UNITED STATES PATENT AND TRADEMARK OFFICE

APPLICATION NO.	FILING DATE	FIRST NAMED INVENTOR	ATTORNEY DOCKET NO.	CONFIRMATION NO.
09/708,766	11/07/2000	James F. Gausling	430672000101	4160

Office Action Summary

DETAILED ACTION

APPENDIX A

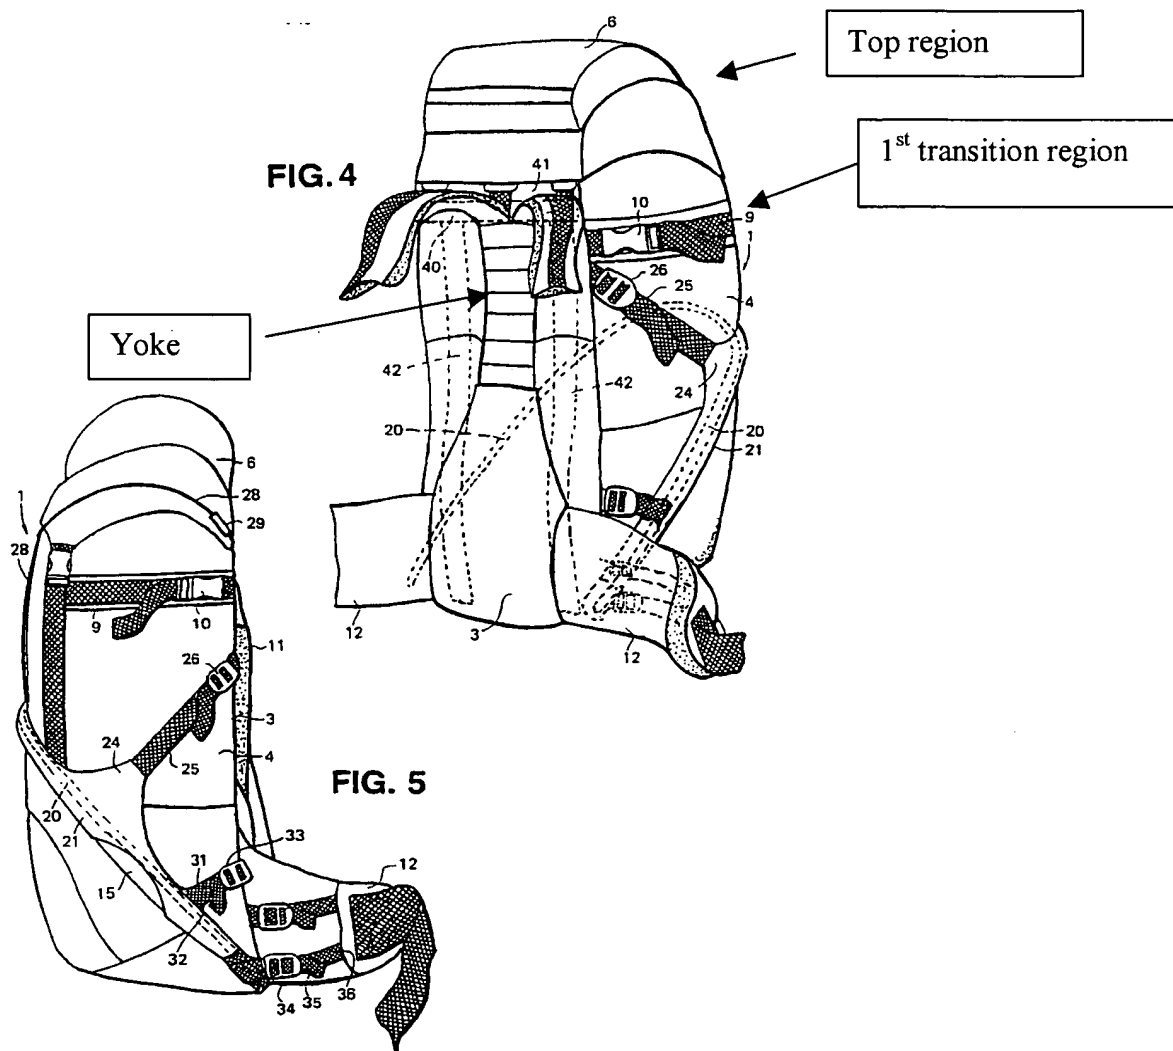
- A backpack body (1);
- A plurality of shoulder support members (11), each having a proximal end connected to the body at a first transition region (Appendix A, Figure 4);

- At least one side support member (Appendix B) disposed adjacent a lateral side region having a proximal end connected to the backpack body at a second transition region between the outer region and the lateral side region and a distal end connected to one of the shoulder support members;

- The body comprises a single, seamless, continuous member to the degree applicant claims;
- The backpack is comprised of nylon;
- A yoke (Appendix A) disposed along the backpack body top region and connected to each shoulder support member;

- Two side support members (Appendix B), each disposed adjacent the first and second lateral side regions, respectively, and each connected to the backpack body at a second transition region and a shoulder support member;

- The distal end of each shoulder support member is connected to the backpack body at a second transition region (Appendix B) between the outer region of the backpack and a lateral side region of the backpack (Figure 6), to the same degree applicant claims;
